Subject: Part 573 Defect and Noncompliance Report: Polar model APX9-1000 and APX9-1200 semi-trailers with aluminum front endframe option.

Safety Defect and Noncompliance Report Guide for Vehicles
PART 573 Defect and Noncompliance Report

Polar APX9-1000 and APX9-1200 pneumatic trailers with optional Aluminum front endframes. Only trailers with the optional Aluminum front endframes manufactured between August 2001 and June 2005 are being recalled. The VIN numbers of the trailers meeting this criteria are attached. See Attachment #1 for the list of affected units and illustrations of the vehicles.

Figure B: Crack Location

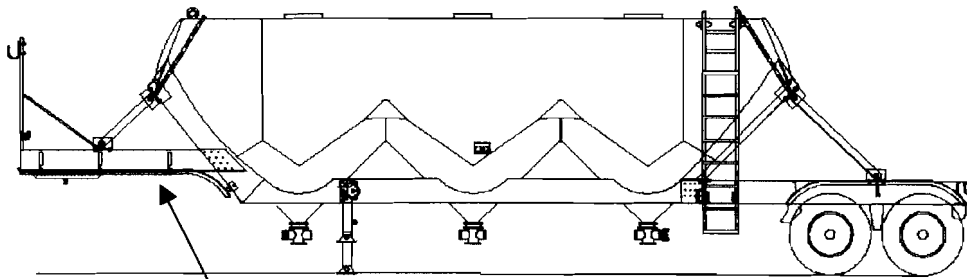
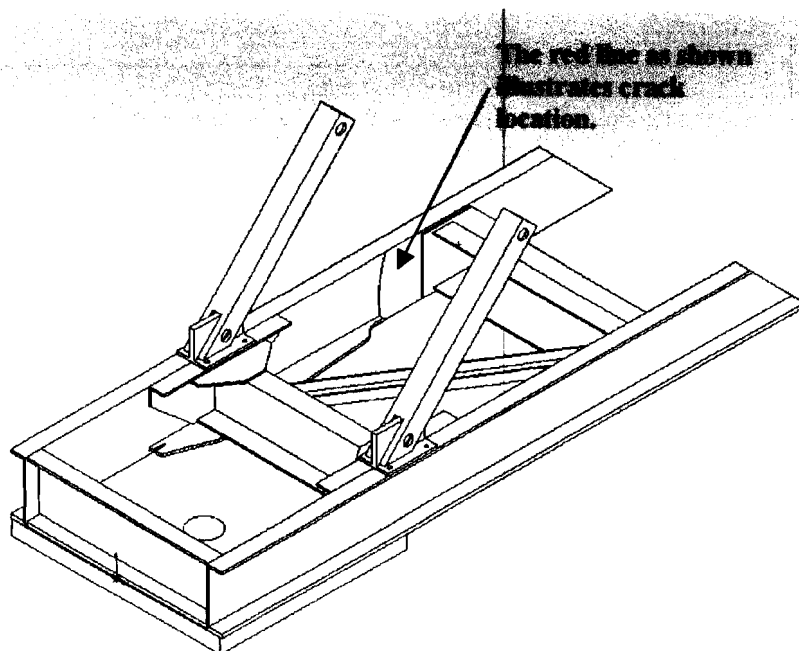
Problem Description:

A crack may develop in the right front frame rail of the front frame, and eventually propagate through the frame.

This occurs because a small crack may start at the termination of a welded gusset, and propagate over time. If undetected, the crack will grow to the point of failure. See Figure B for a detail of the crack location.

SEPA OF
SK-4013**POLAR**
Tank Trailer, Inc.12810 County Road 17
Holdingford, MN 56340
Phone: 1-320-748-2286
Fax: 1-320-748-2937TITLE FRONT FRAME MODIFICATION
CROSSBRACE & ANGLES
PAGE 2 of 4SCALE 1=12
DATE 03/30/97

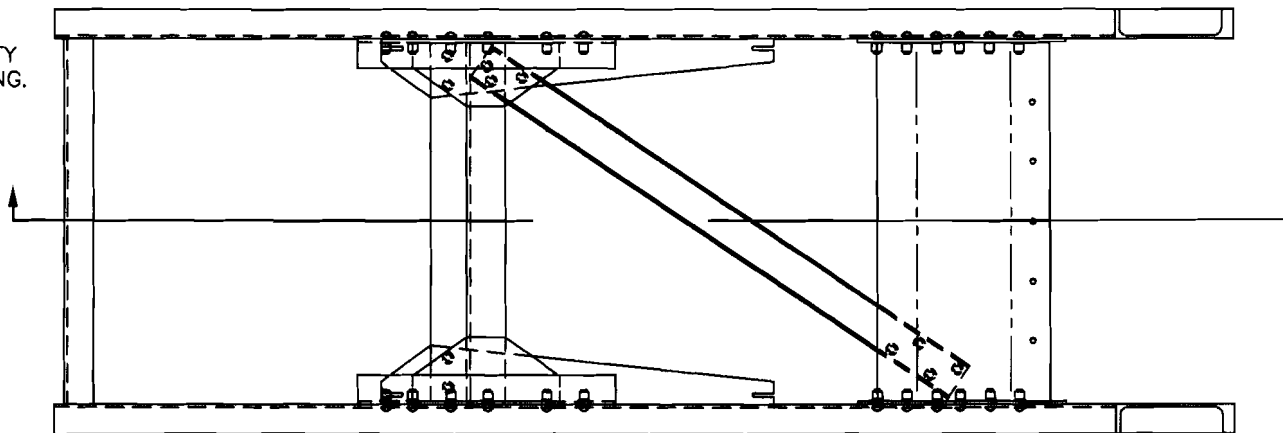
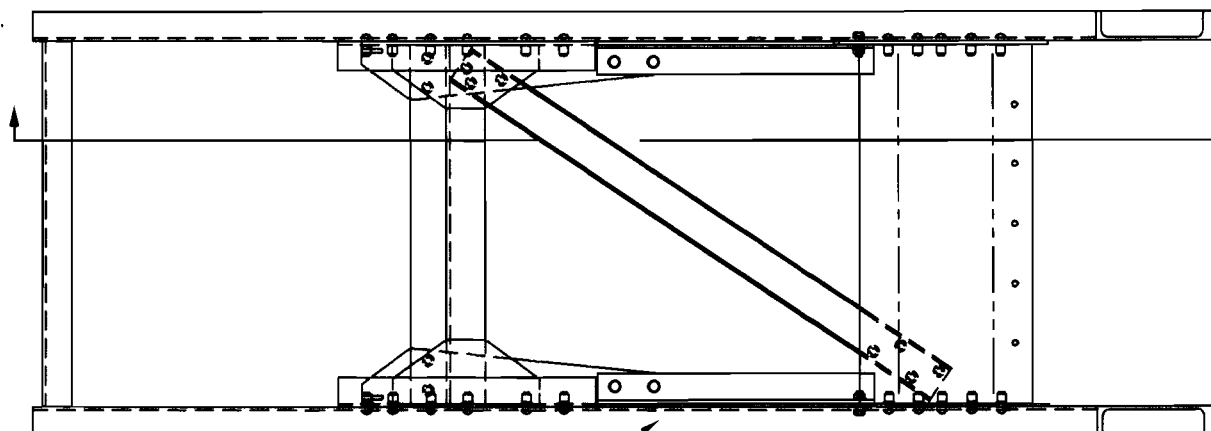
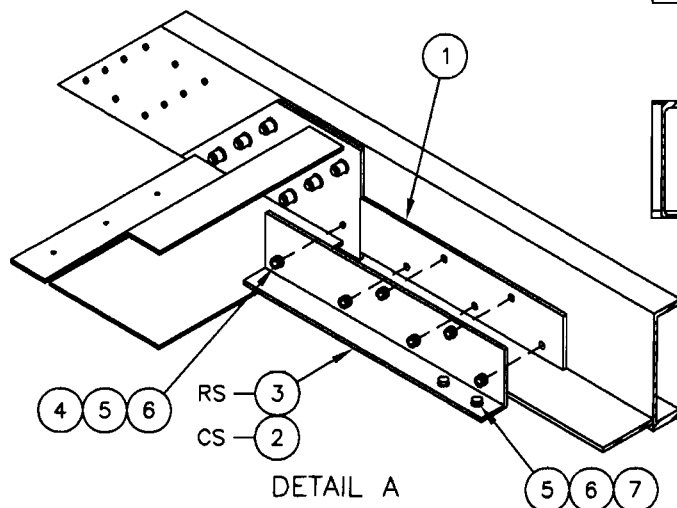
- 1.) INSPECT THE CURBSIDE MAIN FRAME RAIL FOR ANY SIGN OF CRACKING. IF ANY CRACKING IS PRESENT, CALL THE WARRANTY DEPARTMENT AT POLAR BEFORE PROCEEDING. 800-826-6589

- 2.) REMOVE FENDER BRACKET BOLTS AS NEEDED.
 -CUT OFF ANY HUCK BOLTS THAT WILL INTERFERE.
 -ADD SPACER AND ANGLES AS SHOWN TO CURBSIDE AND ROAD SIDE FRAME RAILS. THESE ARE TO SIT DIRECTLY ON TOP OF THE 1/2" GUSSET PLATES THAT ARE WELDED TO THE MAIN FRAME RAILS.
 -ALL PARTS ARE TO BE BOLTED AS SHOWN, NO WELDS.
 -DRILL 11/16" DIA. HOLES AS NEEDED.
 -TORQUE ALL BOLTS TO 159 Ft.-Lbs.

TITLE FRONT FRAME MODIFICATION
CROSSBRACE & ANGLES
PAGE 3 of 4

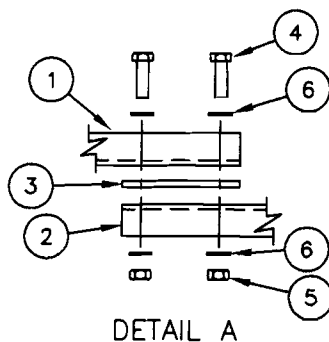
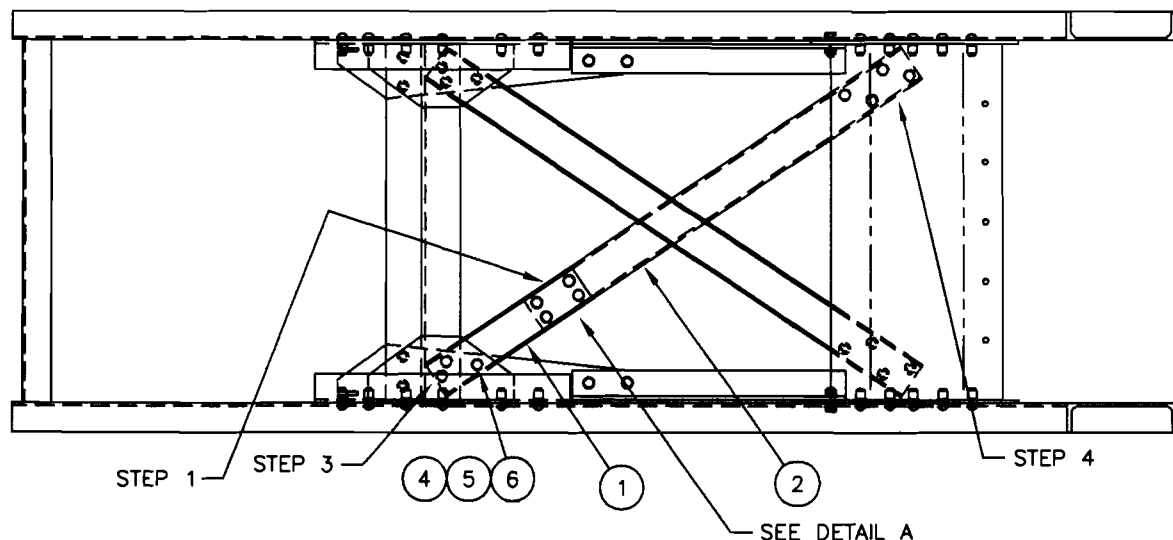
3.) INSTALL CROSS BRACE

- DRILL HOLES IN ENDS OF CHANNELS 1 & 2 WITH HOLE PATTERN FROM SPACER PLATE 3.
- BOLT CHANNELS 1, 2, AND SPACER 3 TOGETHER.
- BOLT END OF CHANNEL 1 DIRECTLY TO TOP OF WELDED GUSSET PLATE.
- BOLT END OF CHANNEL 2 TO BOTTOM SIDE OF REAR CROSSMEMBER PLATE.
- DRILL 11/16" DIA. HOLES AS NEEDED.
- TORQUE ALL BOLTS TO 159 Ft.-Lbs.

TITLE FRONT FRAME REPLACEMENT
AL FRAME, ALUM STRUTS
APX

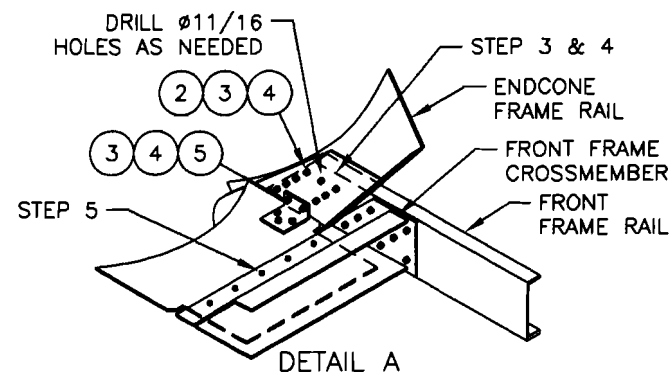
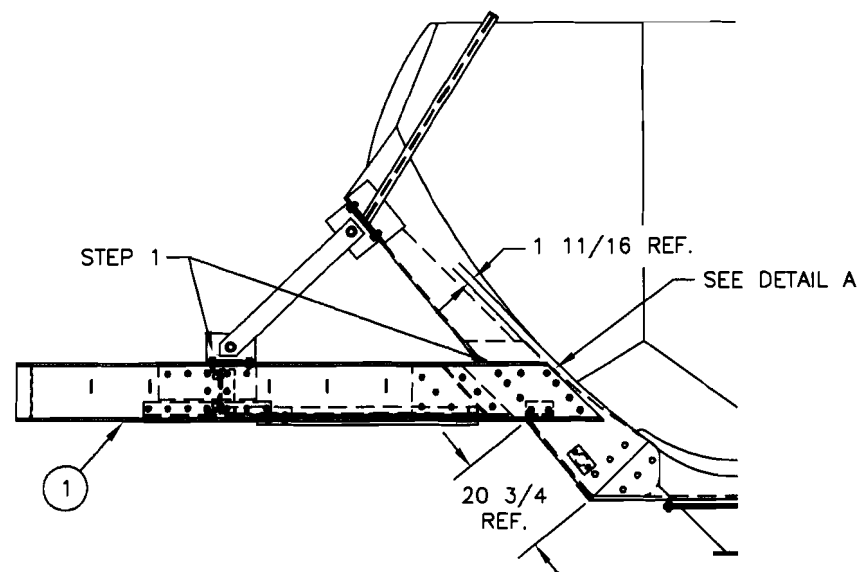
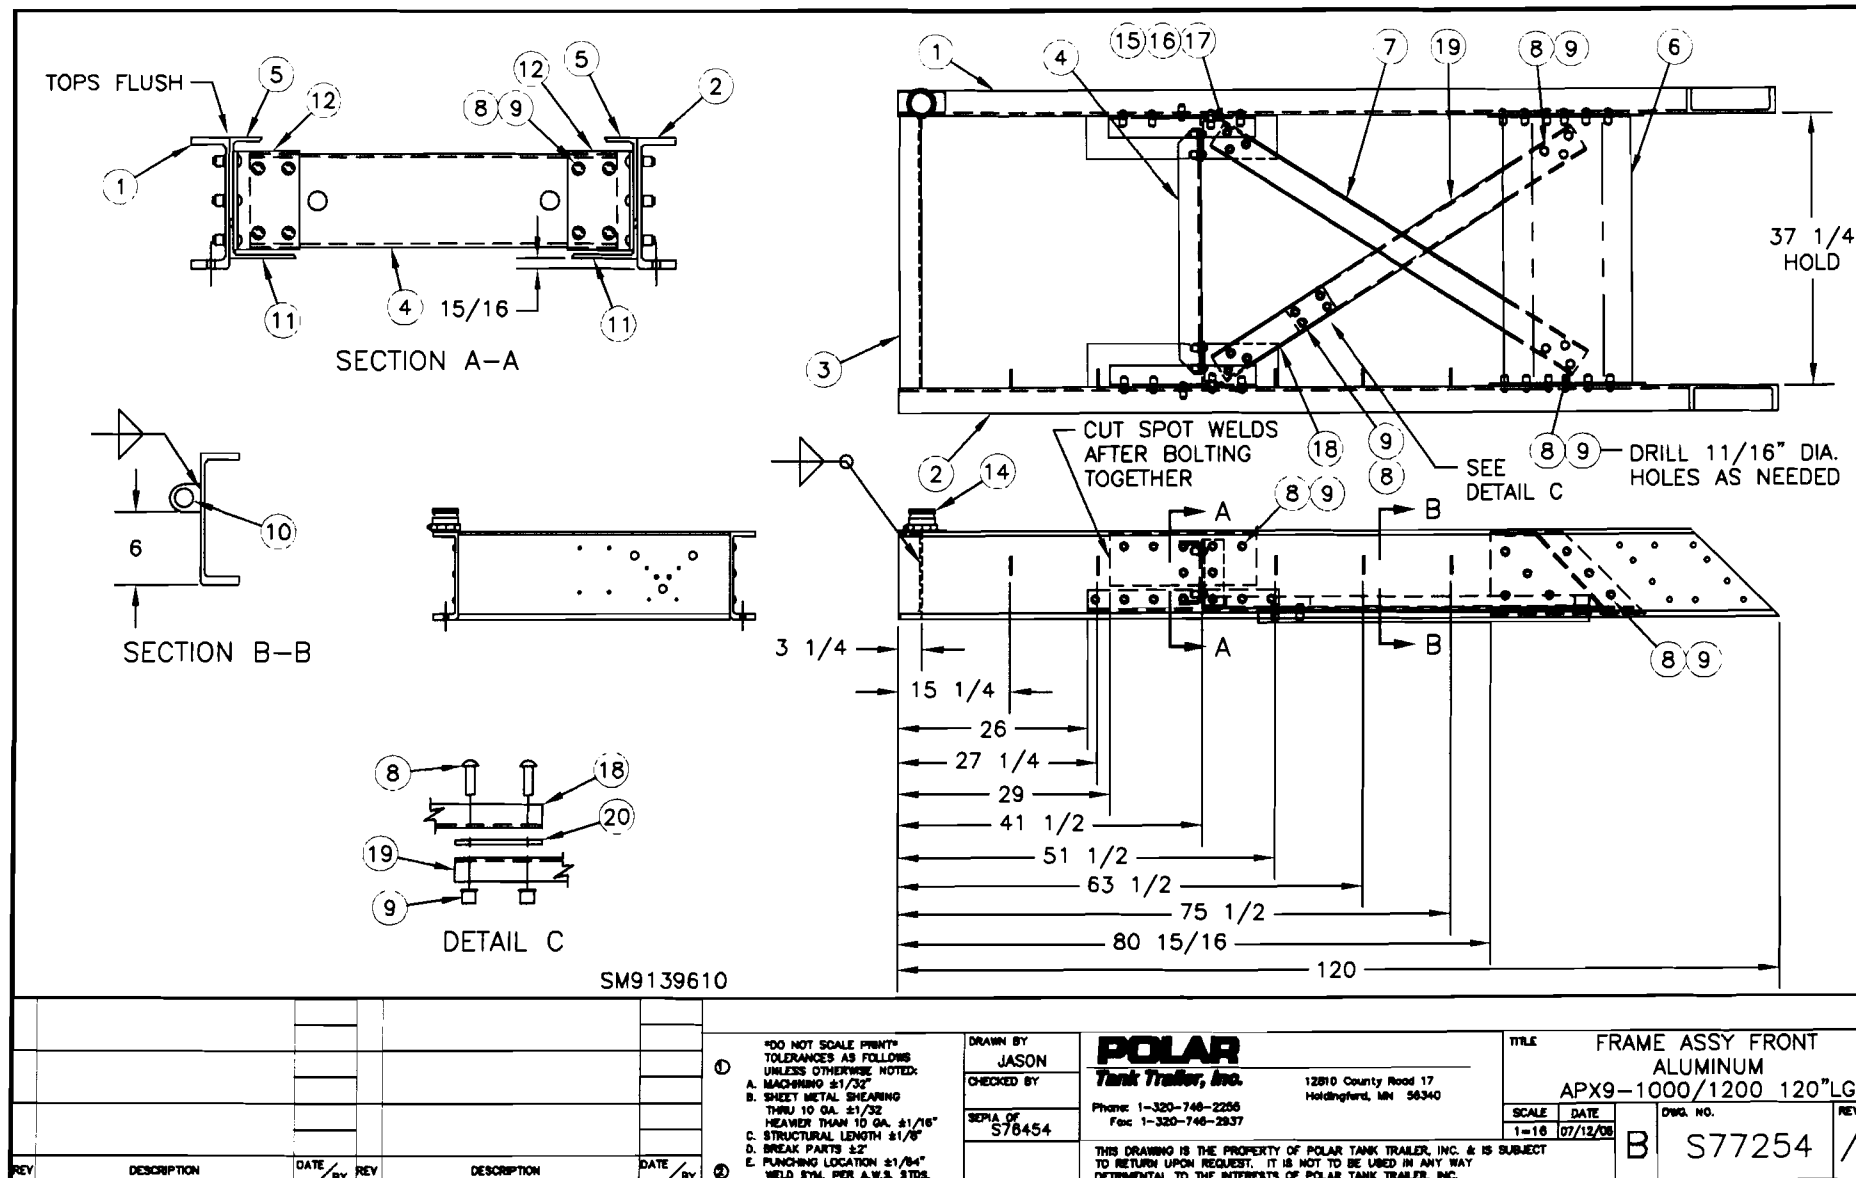
Units with frames being replaced will receive frames constructed per our current production frame design, which utilizes an improved design. The replacement frame has no welded gusset and all welding to the main front frame rail has been eliminated. The frame rail was changed to a stronger extrusion, and a second diagonal brace was added. Attachment #5 shows the replacement frame.

1. REMOVE/CUT BOLTS FOR FENDER BRACKETS, PIPING, STRUTS, FRAME ATTACHMENT, ETC.
2. REMOVE FRAME
3. POSITION NEW FRAME IN SAME LOCATION AS THE PREVIOUS FRAME.
4. MATCH DRILL HOLES FOR FRAME, STRUT, PIPING, FENDER BRACKET ATTACHMENT.
5. RE-BOLT TOGETHER. FRAME AND STRUT BOLTS TO BE TORQUED TO 159 Ft.-Lbs.

Figure B: Crack Location

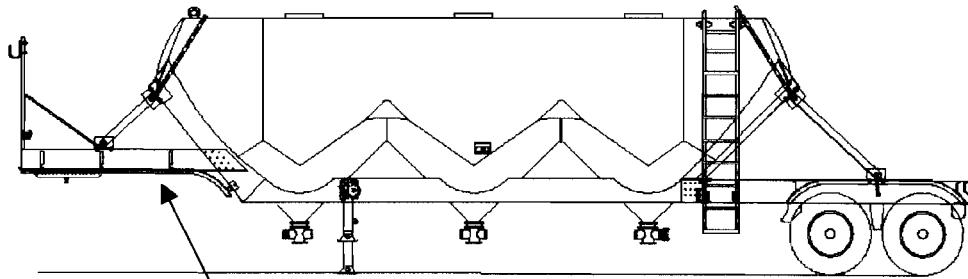
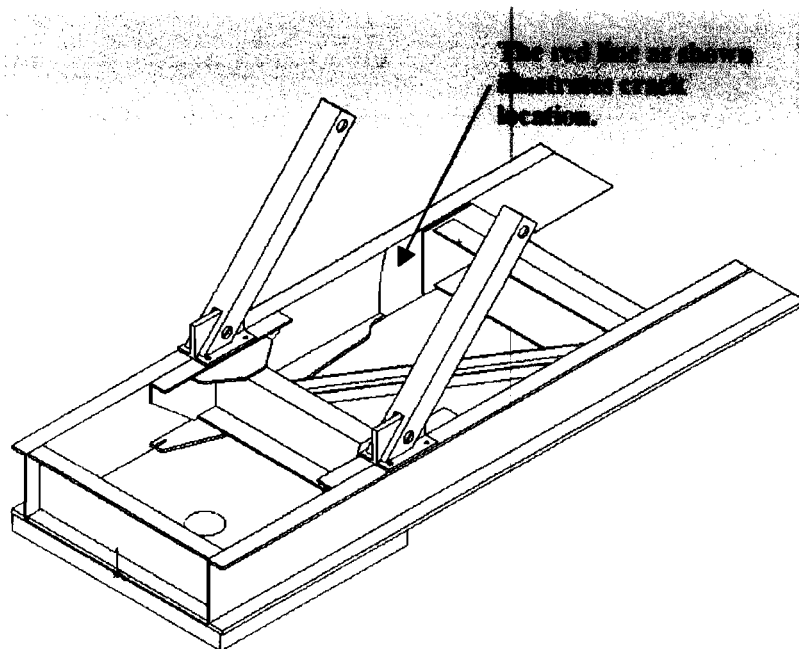
Problem Description:

A crack may develop in the right front frame rail of the front frame, and eventually propagate through the frame.

This occurs because a small crack may start at the termination of a welded gusset, and propagate over time. If undetected, the crack will grow to the point of failure. See Figure B for a detail of the crack location.
